RE: Summit at Powder Mountain Phase 1C
Response to Engineering Comments

The following are comments and responses pertaining to the civil engineering plans from your review and received on December 12, 2013.

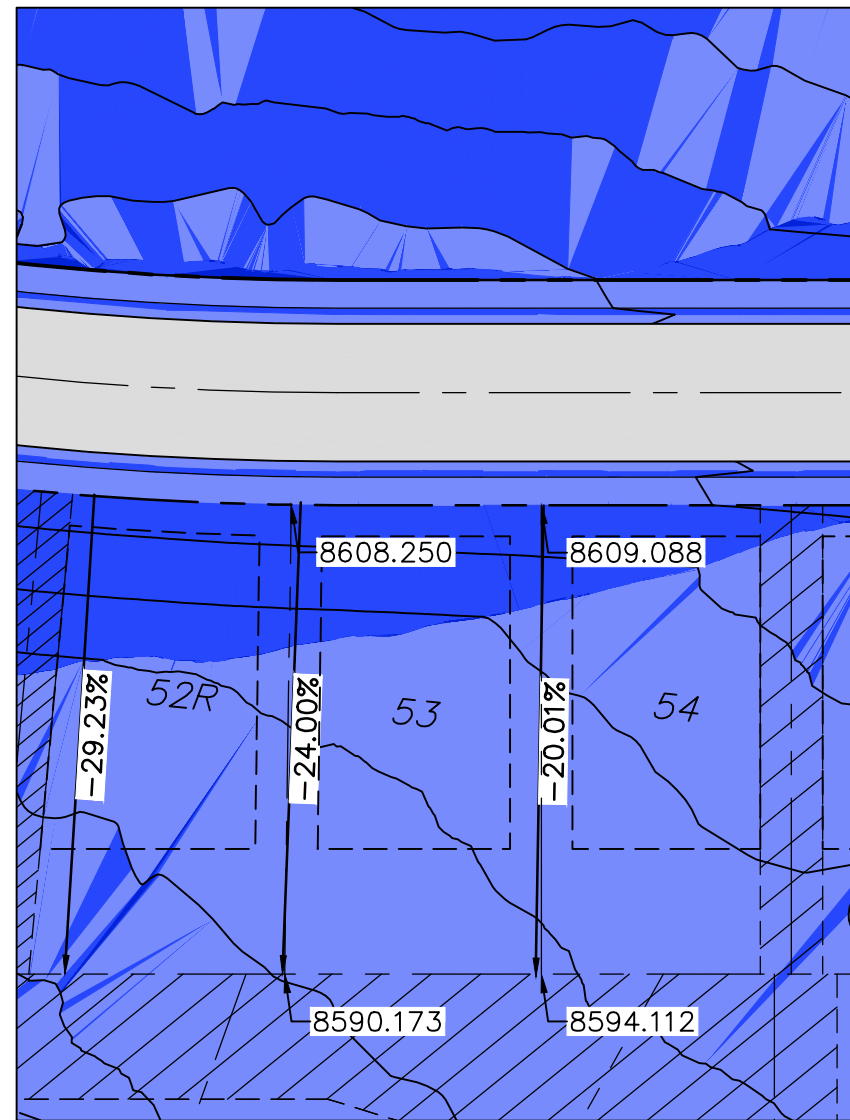
1. All sheets: Based on my calculations, the following additional lots should be classified as “R” lots: 36 & 53 (included in previous review).

Response: After completing our lot slope analysis, Lot 36 meets the 75x100 building pad under 25% slope. Lot 53 is under the 25% max slope. Therefore we feel that those lots should not be classified as “R” lots. See attached exhibit for our findings.
